**From:** Glen McConnell [ | ]  
**Sent:** Wednesday, 18 January 2012 12:04 a.m.  
**To:** Mark Zarifeh  
**Subject:** Report for Commission

Hi Mark, the following is a summation of my involvement in the events leading to the collapse of 116 Lichfield st (Reuben Blades)

## engineer's instruction

project 116 Lichfield St.

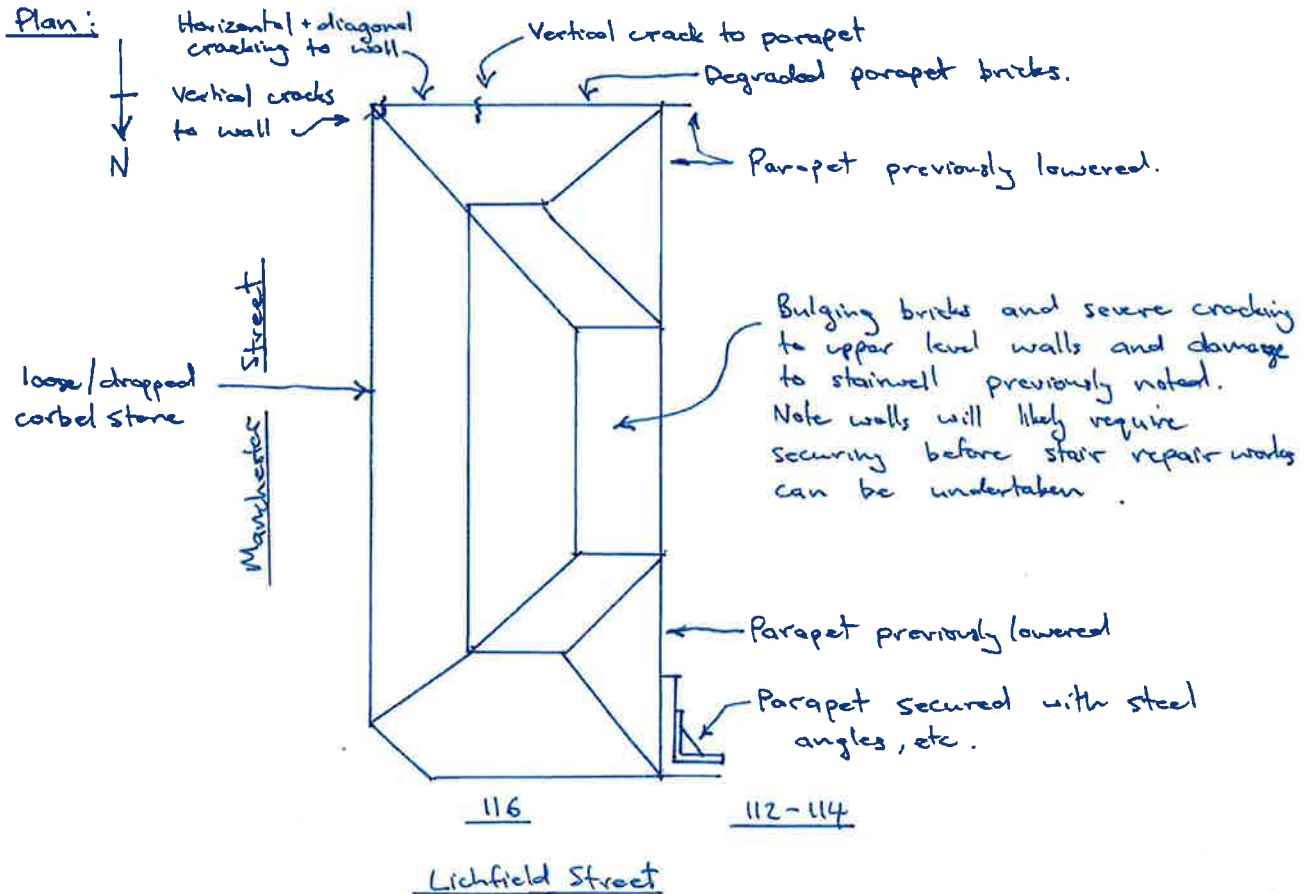
Following advice from contractor we have revisited the property to view further damage from recent earthquakes.

These high level bricks and stone blocks are potential fall hazards to the areas directly adjacent and should be secured as soon as possible, (or the fall areas cordoned off).

We suggest securing works be undertaken as per attached (contractor to wait for insurer approval).

Securing works:

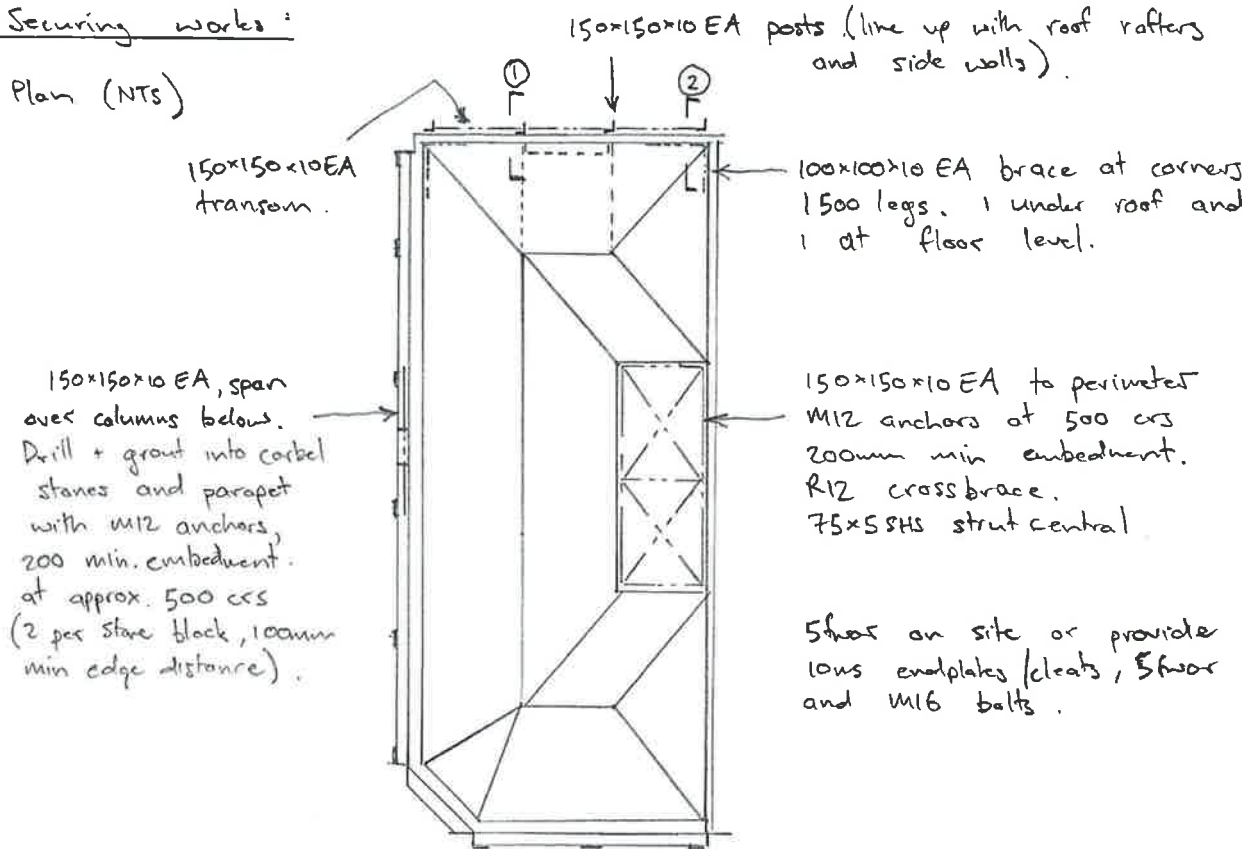
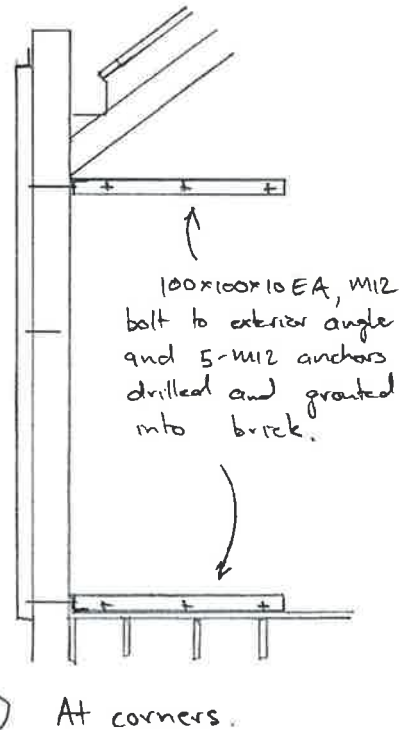
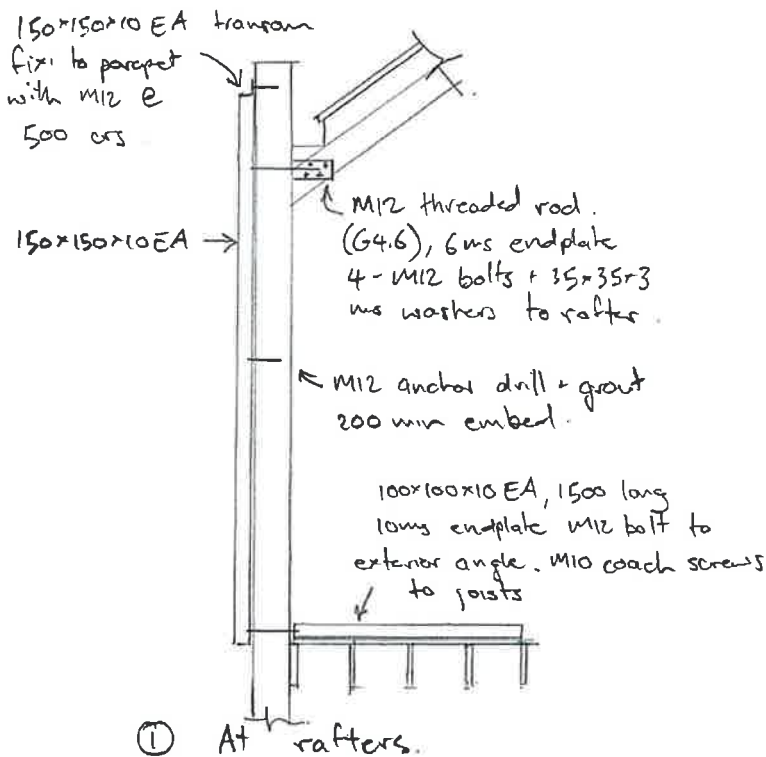
cracks

150x150x10 EA transom  
fix to parapet with M12 e 500 CRS

150x150x10 EA

150 x 150 x 10 EA + M12 anchors  
at 500 c/s to perimeter

75 x 5 SHS

R12 crossbrace

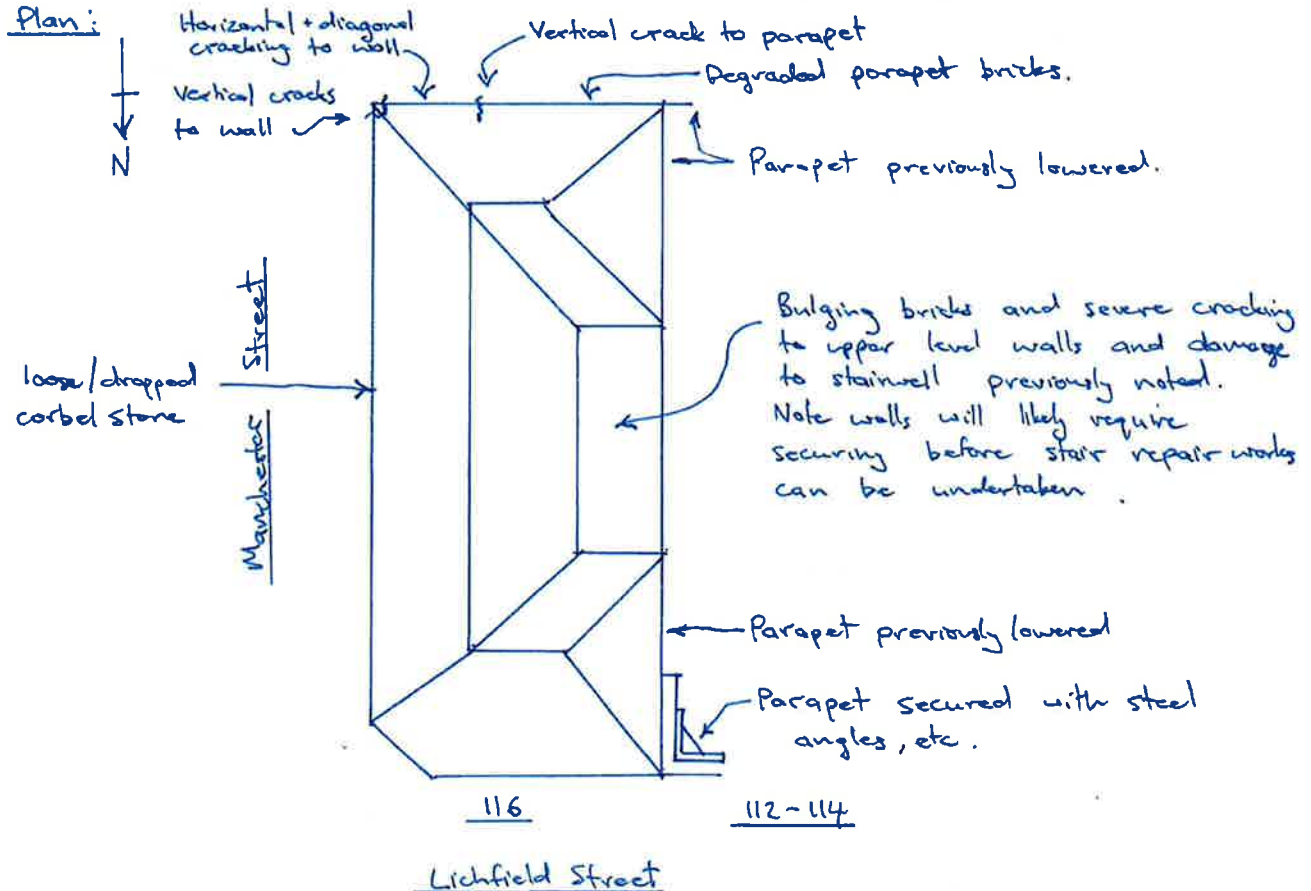
Following advice from contractor we have revisited the property to view further damage from recent earthquakes.

These high level bricks and stone blocks are potential fall hazards to the areas directly adjacent and should be secured as soon as possible, (or the fall areas cordoned off).

We suggest securing works be undertaken as per attached (contractor to wait for insurer approval).
